Access Compliance Report

Public Rights-of-Way

Intersection ID: 26103	Main Street: BEVINGTON_PL	Cross Street: COBURN_CT	Location: W
ADA ID: 2B835F312EEA	Ramp Type: PerpDiag	Initial Pass/Fail: Fail	Overall Compliance: No
Severity Score: 30			
Codes/Mitigation Info/Possible Solution		Field Measurements/Component Compliance

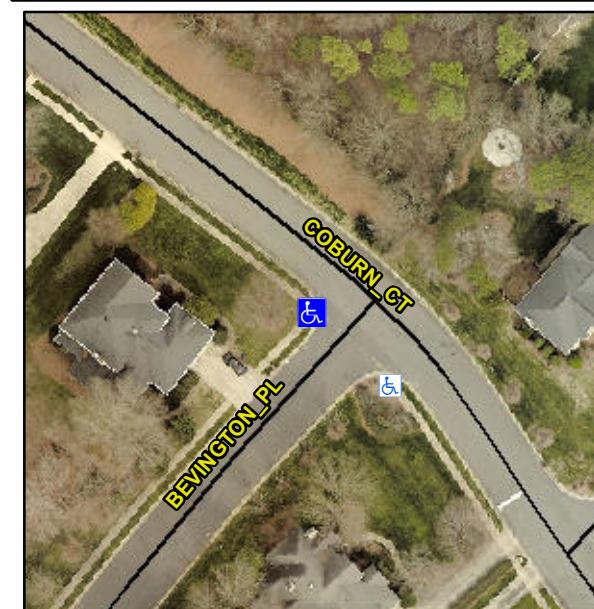
Not Found, R304.5.1, R304.2.2

Compliance	Description	Data	Compliance	Description	Data
N/A	Ramp Length (in)	85.0	No	Ramp Slope (%)	8.7
No	Ramp Width (in)	32.0	Yes	Ramp XSlope (%)	0.7
N/A	Flare Type LT	N/A	N/A	Flare Type RT	N/A
N/A	Flare Slope LT (%)	N/A	N/A	Flare Slope RT (%)	N/A
N/A	Flare Traversable LT?	N/A	N/A	Flare Traversable RT?	N/A
N/A	Landing Length (in)	N/A	N/A	DWS Provided?	N/A
N/A	Landing Width (in)	N/A	N/A	DWS Contrast?	N/A
N/A	Landing Slope (%)	N/A	N/A	DWS Length (in)	N/A
N/A	Landing X Slope (%)	N/A	N/A	DWS Full Width?	N/A
N/A	Landing Curb? (Y/N)	N/A	N/A	DWS Offset (in)	N/A
N/A	Shared Landing?	N/A			
N/A	Gutter Ponding?	N/A	N/A	Gutter Slope (%)	N/A
N/A	Gutter Lip Ht (in)	N/A	N/A	Gutter X Slope (%)	N/A
N/A	Painted X Walk1?	No	N/A	Painted X Walk2?	No
	X Walk 1 Direction	To SE		X Walk 2 Direction	To NE
N/A	X Walk 1 Width (in)	N/A	N/A	X Walk 2 Width (in)	N/A
	X Walk 1 Slope (%)	0.9		X Walk 2 Slope (%)	2.7
	X Walk 1 X Slope (%)	2.5		X Walk 2 X Slope (%)	1.9

Remove & Replace Curb Ramp With Two New Directional Ramps or Equivalent.
